## Access Compliance Report Public Rights-of-Way (Curb Ramps)

Intersection ID: 12056 Main Street: ELLIOTT\_ST Cross Street: W\_MOREHEAD\_ST Location: SW

ADA ID: 1BDE699FF635 Ramp Type: Directional2 Initial Pass/Fail: Fail Overall Compliance: No Severity Score: 12.5

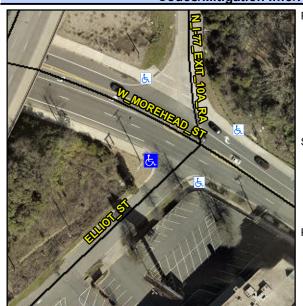
R304.2.2

Field Measurements/Component Compliance					
Compliance Description		Data	Compliance Description		Data
N/A	Ramp Length (in)	64.0	N/A	Grade Break?	N/A
Yes	Ramp Width (in)	108.0	N/A	Grade Break Slope (%)	0.0
No	Ramp Slope (%)	9.0	N/A	Grade Break XSlope (%)	0.0
Yes	Ramp XSlope (%)	1.3			
N/A	Flare Type LT	N/A	N/A	Flare Type RT	N/A
N/A	Flare Slope LT (%)	N/A	N/A	Flare Slope RT (%)	0.0
N/A	Flare Traversable LT?	N/A	N/A	Flare Traversable RT?	N/A
N/A	Landing Length (in)	0.0	N/A	DWS Provided?	N/A
N/A	Landing Width (in)	0.0	N/A	DWS Contrast?	N/A
N/A	Landing Slope (%)	0.0	N/A	DWS Length (in)	N/A
N/A	Landing X Slope (%)	0.0	N/A	DWS Full Width?	N/A
N/A	Landing Curb? (Y/N)	N/A	N/A	DWS Offset LT (in)	N/A
N/A	Shared Landing?	N/A	N/A	DWS Offset RT (in)	N/A
N/A	Gutter Ponding?	0.0	N/A	Gutter Slope (%)	N/A
N/A	Gutter Lip Ht (in)	0.0	N/A	Gutter X Slope (%)	N/A
N/A	Painted X Walk1?	No		Road Slope (%)	5.2
	X Walk 1 Direction	To SE		Road X Slope (%)	2.3

Remove & Replace Entire Ramp.
